AMENDMENT #3 (Corrected)

**Invitation for Bids (IFB) Number
GC-21-WCW1Upgrade-01, 10/19/2021**

**Issued by
Gillespie County Water Control and
Improvement District #1
Fredericksburg, Texas**

GENERAL NOTES
 FLOODWATER RETARDING STRUCTURE SITE No. 1 UPGRADE OF THE
 WILLIAMS CREEK WATERSHED
 IN
 BLANCO, GILLESPIE, & KENDALL COUNTIES, TEXAS

GENERAL PLAN
 FLOODWATER RETARDING STRUCTURE SITE No. 1 UPGRADE OF THE
 WILLIAMS CREEK WATERSHED
 IN
 BLANCO, GILLESPIE, & KENDALL COUNTIES, TEXAS

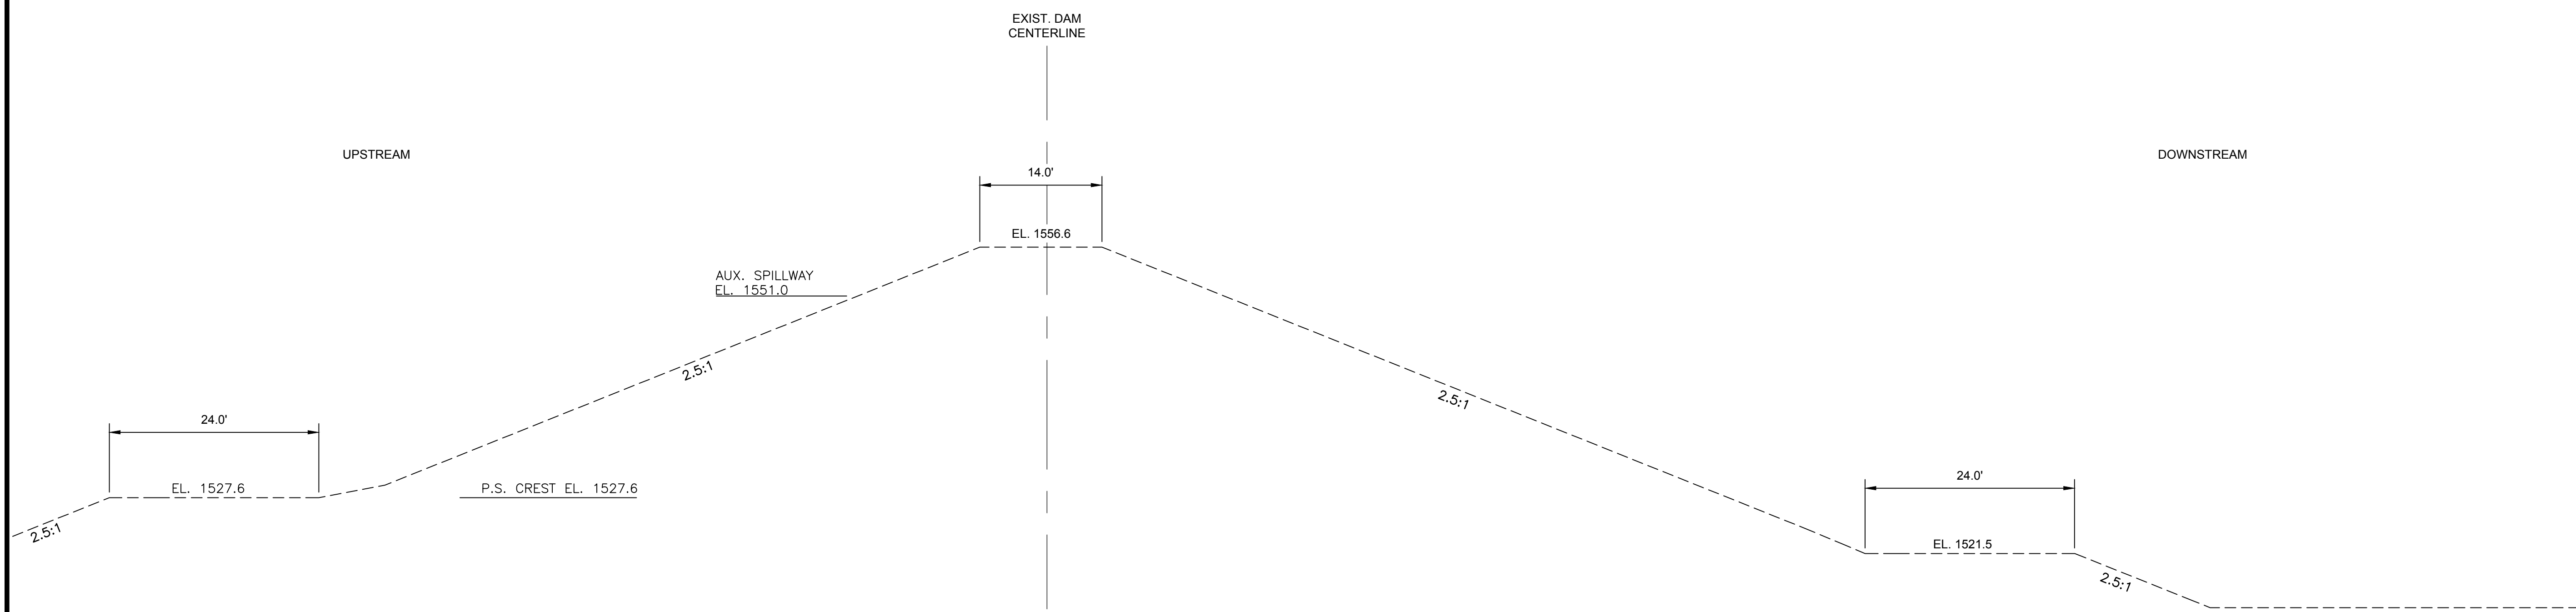
The material specifications for Zone 1 soils have been adjusted to allow the use of soils with a liquid limit less than or equal to 85 within the core of the embankment fill as indicated on the updated typical section on Sheet C-6. The outer shell of the embankment, within the limits designated, shall consist of Zone 1 soils with a liquid limit less than or equal to 70. **The plasticity index of Zone 1 has been adjusted to allow use of soils with a plasticity index of 60 or less.** The material placement data table on Sheet G-2 has been updated accordingly. The borrow area limits shall be extended, if necessary. Final limits of the borrow area shall be approved by the Owner.
